The Sizewell C Project

5.1 Consultation Report Addendum - Annex A: Unredacted Statutory Consultee Responses

Revision: 1.0
Applicable Regulation: Regulation 5(2)(q)
PINS Reference Number: EN010012

Consultation on proposed changes

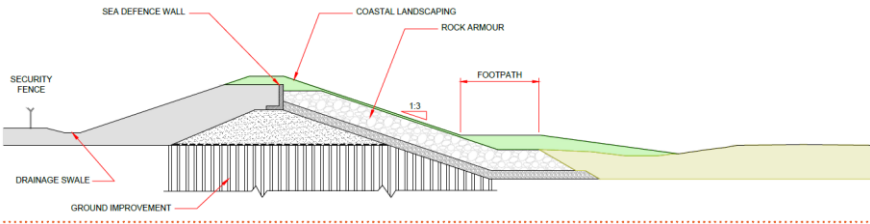
<p>the rock structure. The hydraulic performance of rock revetments depends on the voids being open to aid the attenuation of energy within them. Filling them up would only diminish the eventually needed hydraulic properties, potentially aggravating overtopping wave absorption and stability of outer layer rocks, whilst increasing unwanted wave reflection.</p>	<p>introducing soil to the rock revetment are taken into account and designed for.</p>	
98	4.8.7	<p>Figure 4.18 Temporary sea defence</p>	<p>The figure does not provide any dimensions, levels, or positional reference. Without quantitative detail the figure is of limited usefulness.</p> <p>A query also on the impact of the vertical wall when exposed to waves. The wall is expected to be exposed to wave action, in fact the design provides for a heightening of the wall to cater for future conditions.</p>	<p>Request for Further Information: Please provide a version of this drawing complete with levels and dimensions. Please advise the impacts of such a wall on the beach to seawards, and how this would be managed.</p>

<p>4.8.7. An alternative sheet-pile sea defence is proposed for the construction phase of the project, as illustrated in Figure 4.18. This alternative design has similar performance features to the construction phase HCDF within the Application, but significantly increases the amount of space within the construction site for marine shafts and tunnelling and simplifies the construction process, as explained in more detail in this section. The temporary sea defence would have a maximum height of approximately +7.3m AOD for the majority of its length and would then raise further (to approximately 10.5 AOD) to meet the SZB sea defence.</p>	<p>Being a vertical wall it would be reflective to waves. Subject to it being high enough, it has potential to be an effective barrier to sea incursion. However, this means that wave energy that would otherwise be expended at the shore will be maintained on the seaward side of the wall where it would likely cause localized erosion and suspension of sediments, leading potentially to accelerated sediment loss.</p>

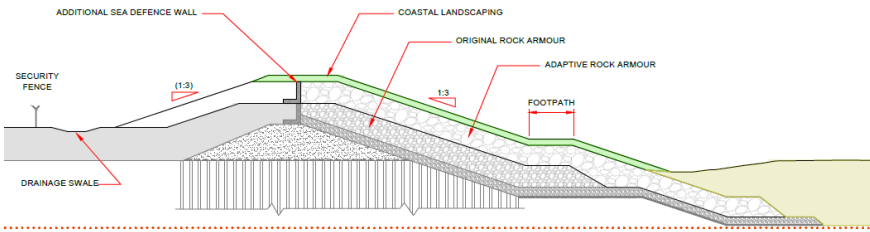
98	4.8.10	<p>4.8.10. The design of the buried toe of the sea defence has been further progressed in response to stakeholder feedback and will now be set at approximately 0mAOD at the outset of the operational phase.</p>	<p>Without further detail on the Figure it is supposed that the 0mAOD refers to the underside of the toe. It is usual for the toe to extend below the deepest level that natural erosion can reach. Even allowing for future adaption of the defense structure, this interim level would appear to be rather shallow.</p>	<p>Confirmation required: has the security of the toe against beach losses and scour been fully investigated and designed for? What is the designed-for lowest beach level that's taken into account?</p>	
99	Fig. 4.20	<p>Figure 4.20 Permanent sea defence, adaptive design</p> 	<p>The figure does not provide any dimensions, levels, or positional reference. Without quantitative detail the figure is of limited usefulness.</p> <p>This figure more clearly identifies the coastal landscaping. There must be suitable geotextile or suitable membrane the isolate the landscaping soil from the voided rock mound.</p>	<p>Request for Further Information: please reissue this and similar drawings complete with dimensions, levels, and positional references, e.g. in relation to MHWS line, and the SCDF.</p>

<p>Please provide details of how the landscaping material is to be isolated from the voided rocks.</p> <p>Also please advise as per the comment on p97 4.8.4.</p>	
100	Table 4.6	<p>Coastal Geomorphology and Hydrodynamics</p> <p>There would be no change to the present-day baseline environment for coastal geomorphology and hydrodynamics (because the coastal defence is set back from the coast).</p>	<p>The installation is expected to be in place beyond the present day, i.e. for up to 190 years (?), during which time the HCDF will interact directly with the coastal processes. As a result, the HCDF has potential to have negative impacts on the coastal processes. The change to the length of the structure seawards means that any such negative impacts will happen sooner.</p>	<p>Clarification required: the Table 4.6 statement is unclear and needs to be expanded to reference the future evolution of the shore with respect to the changed length of the structure.</p>
